Fakir Apparels Ltd. (Extension)

14 November 2023 & 1 January 2024

2. Observations

Observation-3: Incomplete retrofitting works (FAL-27A).

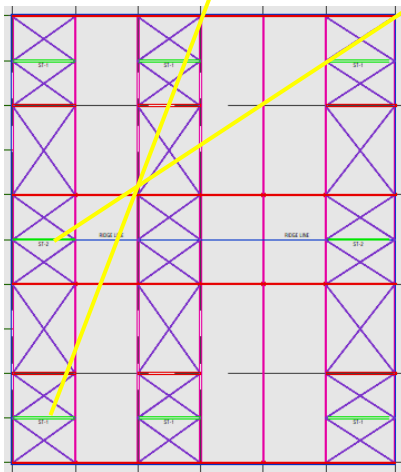
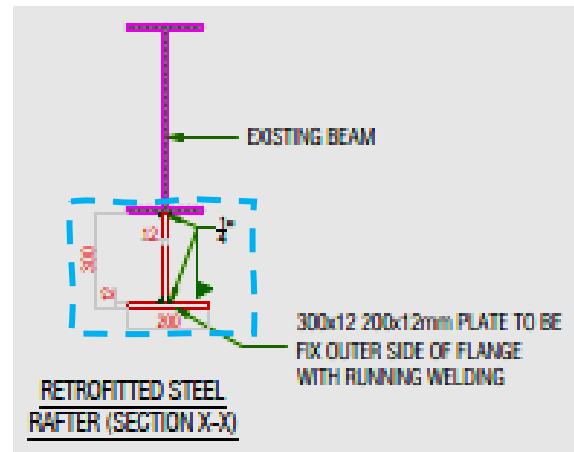
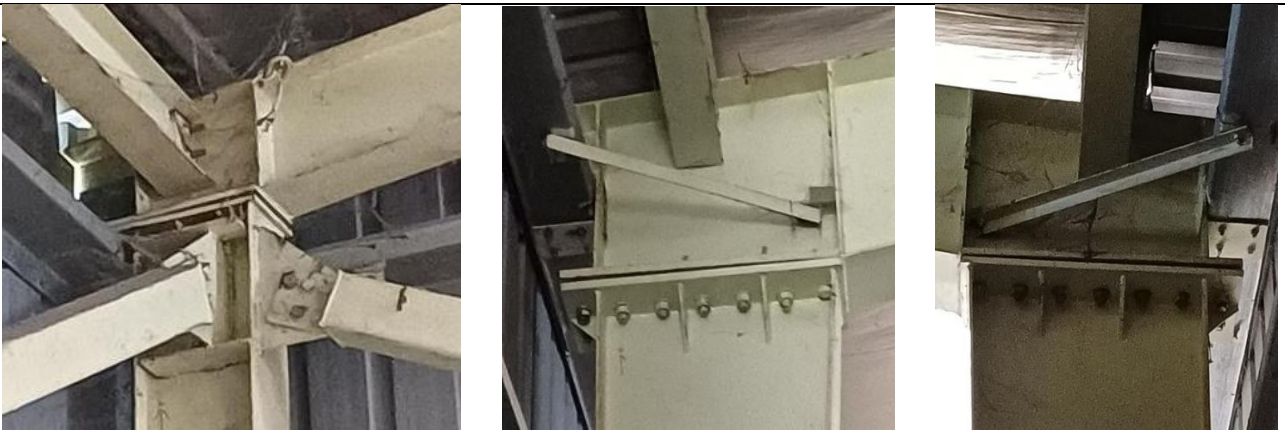
Proposed retrofitting on rafter in interior grid

Proposed strut layout

Proposed additional tee bottom of the rafter

Description: The factory has prepared the DEA of the shed. As per the recommendation of the DEA, some retrofitting works are suggested but no retrofitting work was carried out. The building engineer is required to submit the DEA report to RSC for review before the start of retrofitting work.

Observation-7: Discrepancies in as built drawings. (FAL 28- Central Chemical Store)

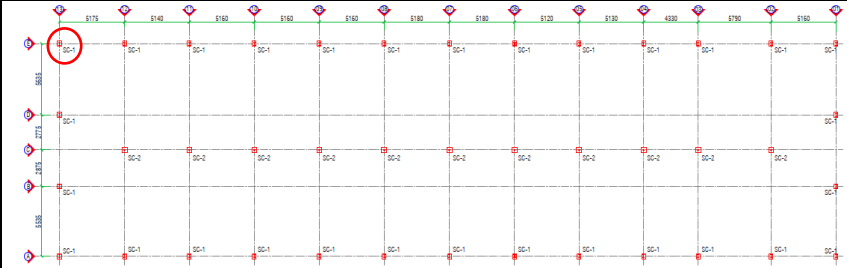
Description: During inspection, mismatches were found between onsite condition and as-built drawing. Steel pipe column SC2 was found dia 115 mm instead of dia 100 mm. The building engineer is required to survey the full structure and produce accurate as-built drawings.

Observation 13: Discrepancies in as-built drawings. (FAL 30- ETP chemical & sludge storage area)

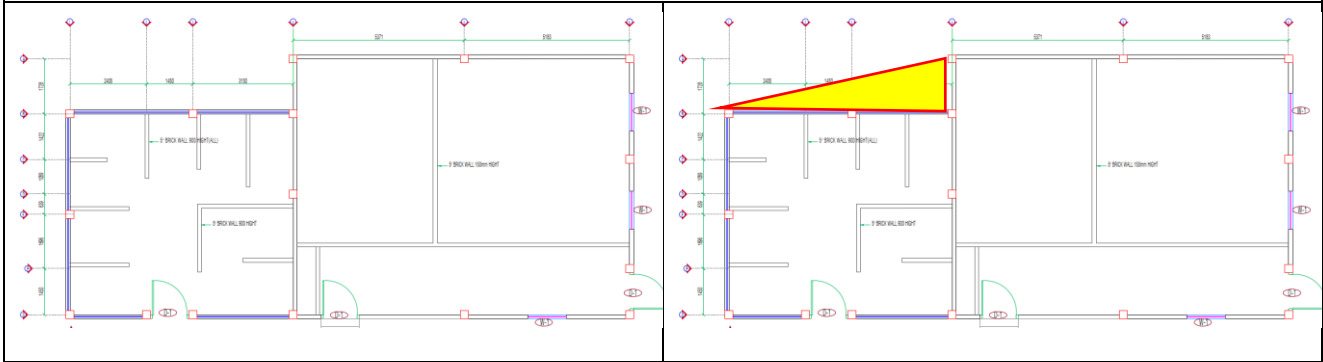
Architectural drawing

Actual shape of FAL 30

Description: During the inspection, a mismatch was found in the building plan shape. The building engineer is required to survey the full structure and produce accurate as-built drawings.

Observation-20: Discrepancies in as-built drawing (FAL-34).

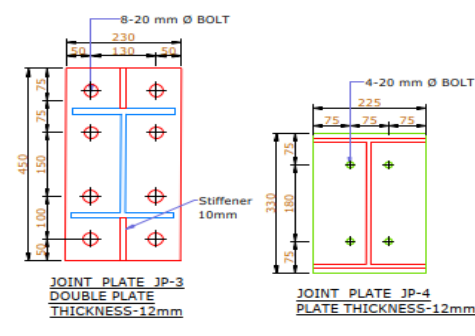
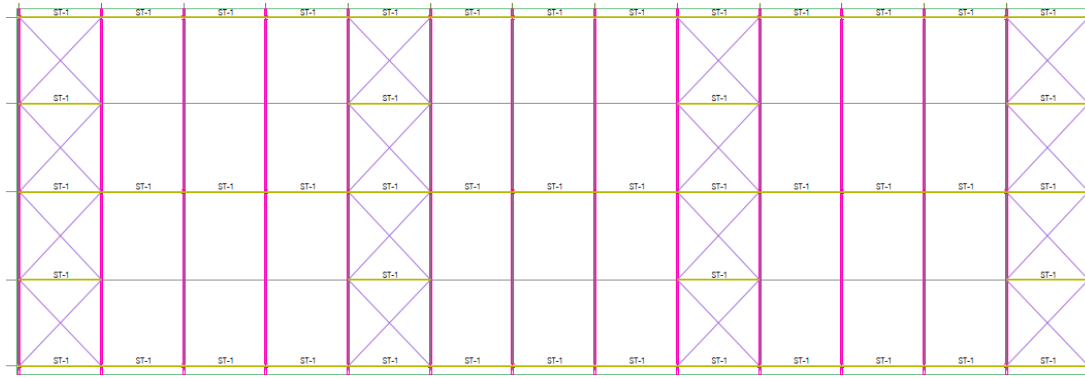
Actual flange thickness

Onsite condition (JP3)

Connection Details: JP3 & JP4

Onsite condition (JP4)

Description: During the inspection, the flange thickness of the marked steel column was found 8mm instead of 10 mm and the bolt diameter of connection JP3 & JP4 were observed below 16mm instead of 20 mm. The building engineer is required to survey the whole structure and produce as-built drawings as per actual site conditions.

Observation-21: Incomplete retrofitting works (FAL-34).

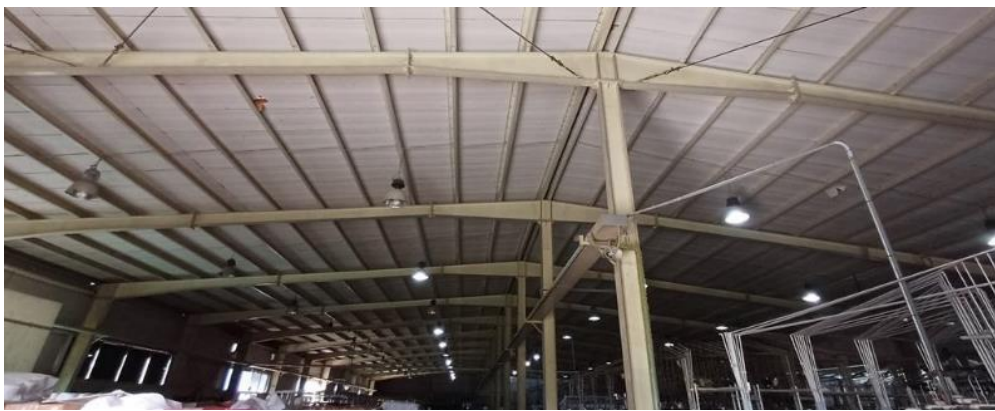
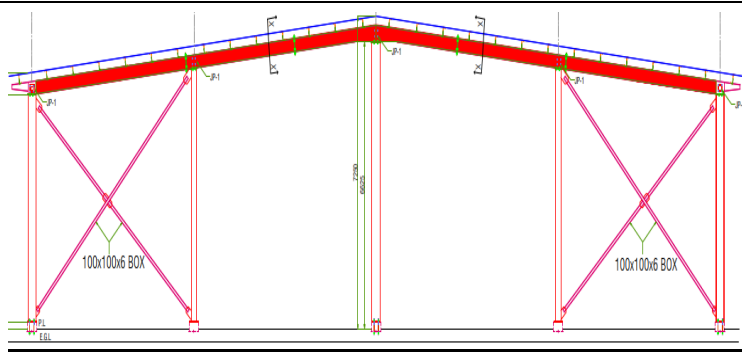
Proposed compression strut layout

No compression strut in the long direction

Proposed wall bracing and rafter retrofitting

No wall bracing and rafter retrofitting

Description: The factory has prepared the DEA of the shed. As per the recommendation of DEA, some retrofitting works were suggested but no retrofitting work was carried out.

Building engineer is required to submit the DEA report to RSC for review before the start of retrofitting work.

Observation-22: Corrosion on steel member (FAL-34).

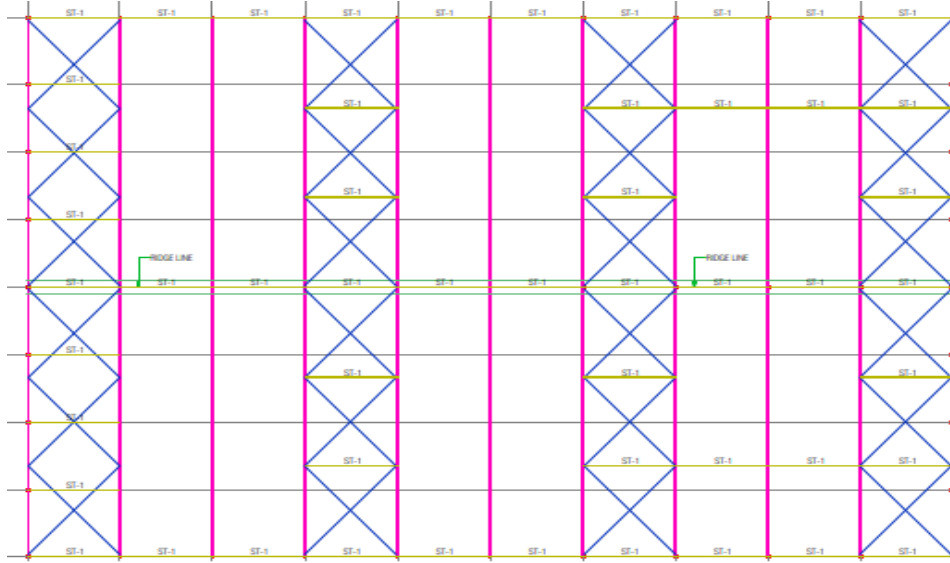
Description: During inspection, corrosion was found on several steel members. Factory is required to remove rust and apply rust-proof paint on steel members.

Observation-24: Incomplete retrofitting works (FAL-35).

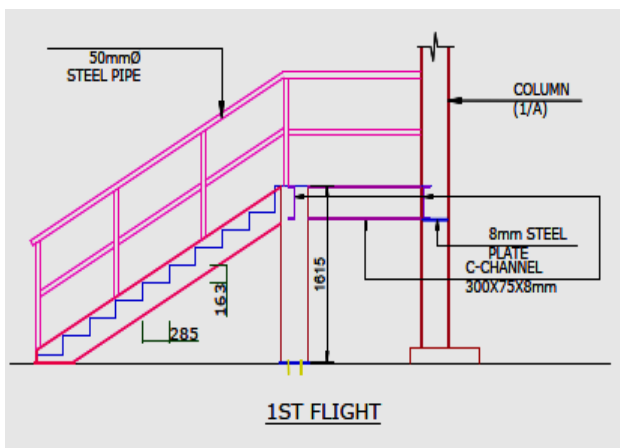
Proposed compression strut layout

No compression strut in the long direction

Proposed wall bracing and rafter retrofitting

No wall bracing and rafter retrofitting

Description: The factory has prepared the DEA of the shed. As per the recommendation of the DEA, some retrofitting works were suggested but no retrofitting work was carried out.

Building engineer is required to submit the DEA report to RSC for review before the start of retrofitting work.

Observation-26: Discrepancies in as-built drawing (FAL-37).

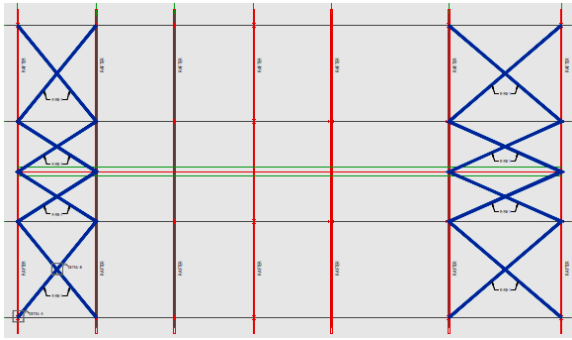
Description: During the inspection, the C-channel depth of the stairs was found 275mm instead of 300 mm. The building engineer is required to survey the whole structure and produce an as-built drawing as per actual site condition.

Observation-27: Incomplete retrofitting works (FAL-37).

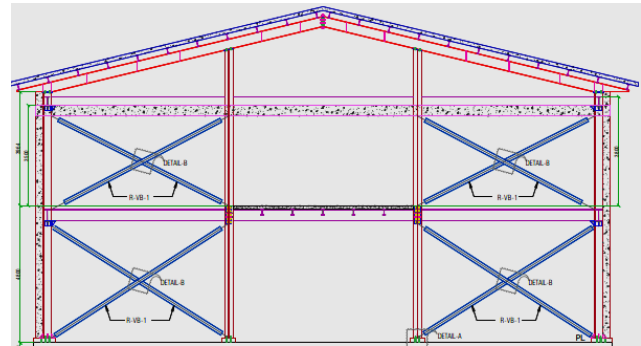
Proposed roof bracing

Proposed wall bracing

No roof or wall bracing

Description: The factory has prepared the DEA of the shed. As per the recommendation of the DEA, some retrofitting works are suggested but no retrofitting work was carried out.

Building engineer is required to submit the DEA report to RSC for review before the start of retrofitting work.

Observation-30: Inconsistency in drawing. (FAL 40- Medical & daycare)

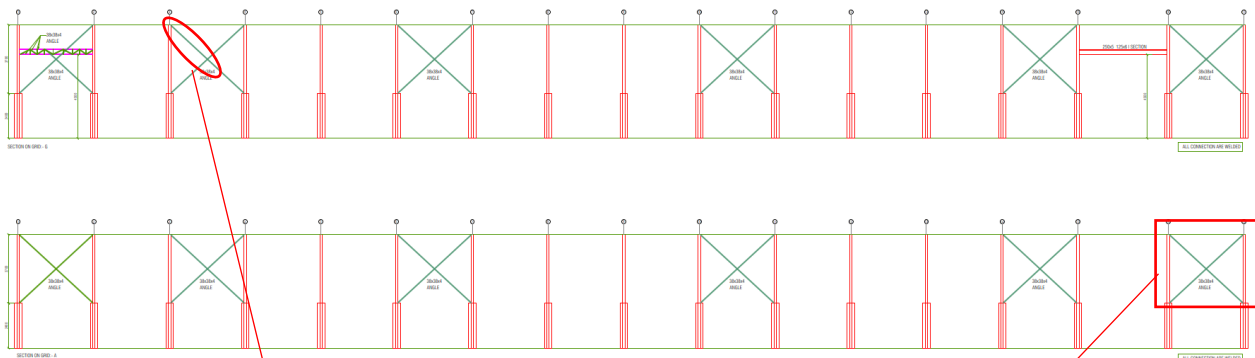
Wrong column retrofitted

External Steel stair connected with Medical & daycare building.

Description: During the inspection, a mismatch was found between the drawing and on-site condition. As per the drawing, the wrong column was found retrofitted which was marked in the figure. Retrofitting details of column and foundation were found missing in the drawing. Also, external steel stairs were found connected with structural members of Medical & day care building. The building engineer is required to survey the whole structure and update the as-built drawings and perform Detail Engineering Assessment (DEA).

Observation-32: Discrepancies in as-built drawings. (FAL 42- Dyeing Finishing)

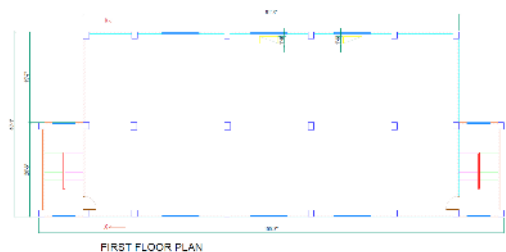
Description: During the inspection, mismatches were found in the vertical bracing layout between the onsite condition and the as-built drawing. The building engineer is required to survey the full structure and produce accurate as-built drawings.

Observation-34: Discrepancies in as-built drawings (FAL-43).

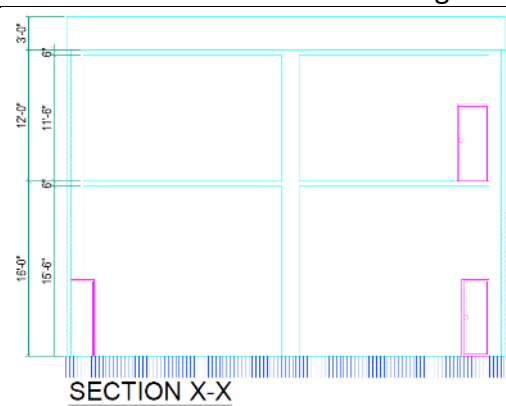
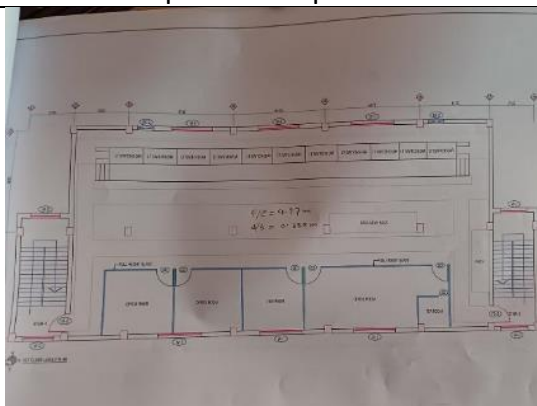
Floor buildup below LT panels at 1st floor

Floor to ceiling height (4.27 m)

Description: During the inspection, mismatches were found between the onsite condition and the as-built drawing. Floor built observed on 1st floor below LT panels. Also. The floor-to-ceiling height doesn't match the as-built drawing. A building engineer is required to prepare accurate as-built drawings.

Observation-39: Discrepancies in as built drawings (FAL-44).

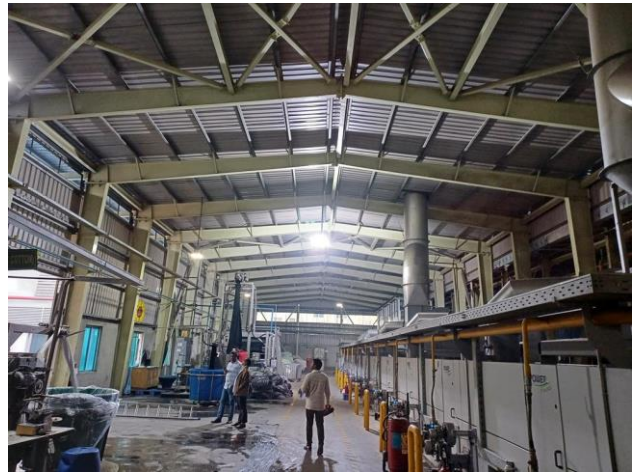
Steel truss along both directions

Misalignment of steel truss

Description: According to the on-site condition, steel truss is connected to steel columns along both directions. The steel truss alignment is not straight along short direction. In as built structural drawing, truss is not shown in the short direction both in plan and elevation. The building engineer is required to prepare accurate as-built drawings based on actual site condition.

Observation-45: Discrepancies in as-built drawing (FAL-48).

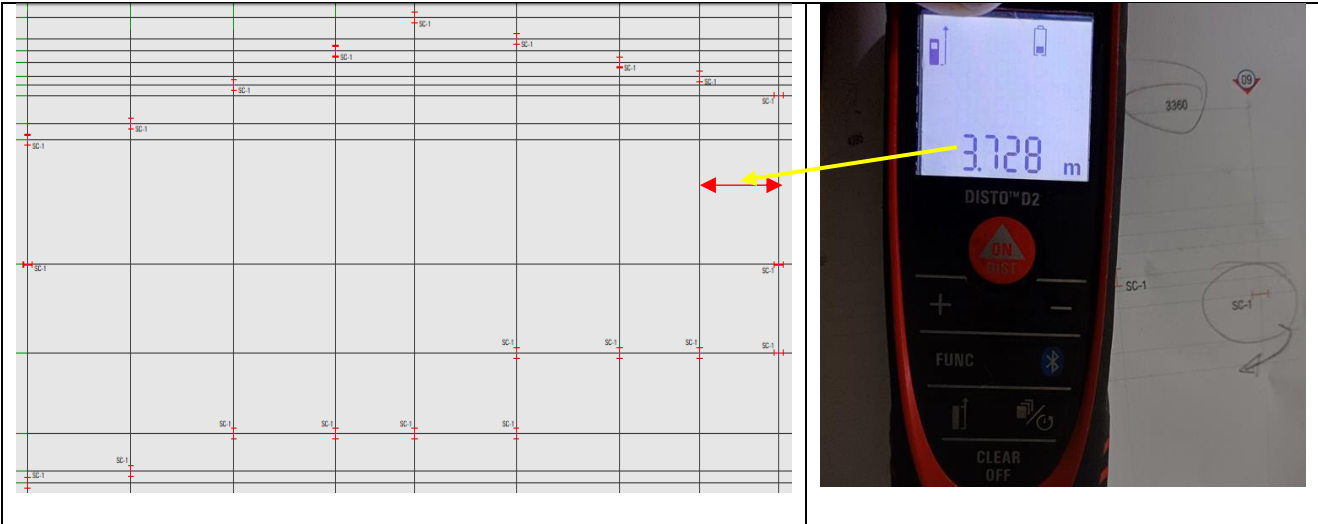
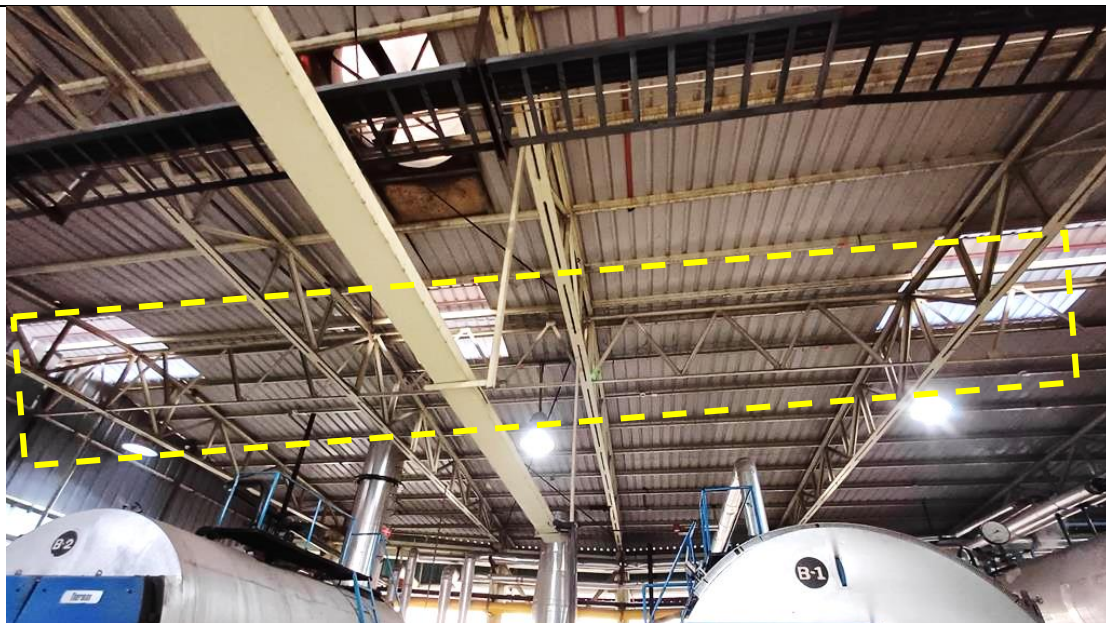
Orientation mismatch - marked columns

Marked grid dimension was observed 3.728 m instead of 3.36 m

The thickness of wall bracing was found 5.3 mm instead of 6 mm

No drawing of truss in the long direction

Description: During the inspection, mismatches (column orientation, wall bracing size, grid dimension, no drawing of truss in a long direction) were observed. The building engineer is required to survey the whole structure and produce as-built drawings as per actual site conditions.

Observation-51: Inconsistency in design report (FAL-54).

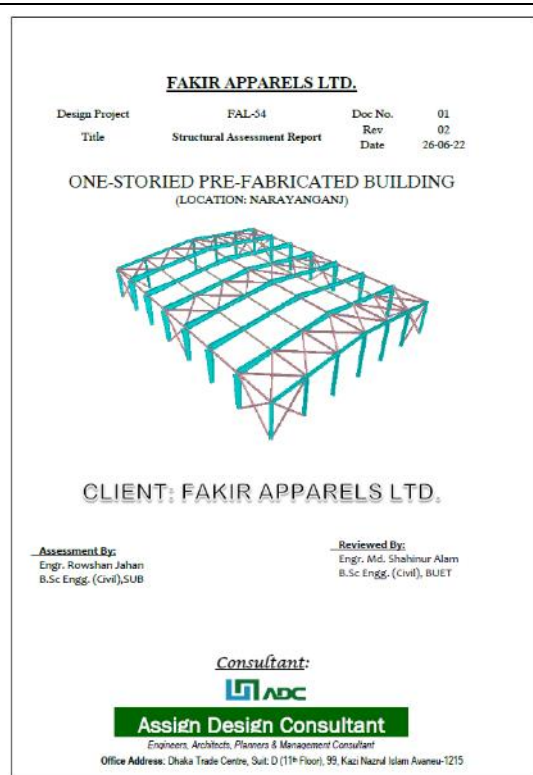
Description: In the design report, steel connections, concrete members, and foundation adequacy checks are not provided. The building engineer is required to update the design report based on in-situ material strength, sub-surface condition and software-based analysis. Submit it to the RSC for review.
